MEMORANDUM

Project No. 100094-I-11

Re: Crownhill Elementary: Addendum to the Groundwater/LNAPL Monitoring and Contingency Plan

Addendum to the Groundwater/LNAPL Monitoring and Contingency Plan Crownhill Elementary, Bremerton, Washington

Figure 2. Schematic of Well Construction, Partially Saturated Screens

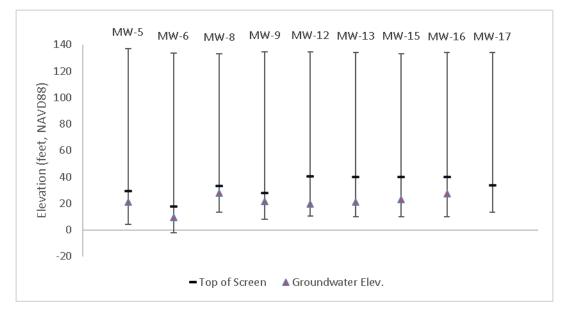
Locations. Monitoring wells at the Site were constructed with a partially saturated screened section, based on the well logs provided as Appendix A and observed water levels. Figure 2 below shows the observed water levels and screen settings for each of the wells selected for the soil gas survey. The partially saturated screen allows for monitoring deep soil gas concentrations in contact with groundwater by conducting a soil gas survey. The soil gas survey will require temporarily replacing the wellhead cap and should not affect groundwater sampling results or other cleanup actions.
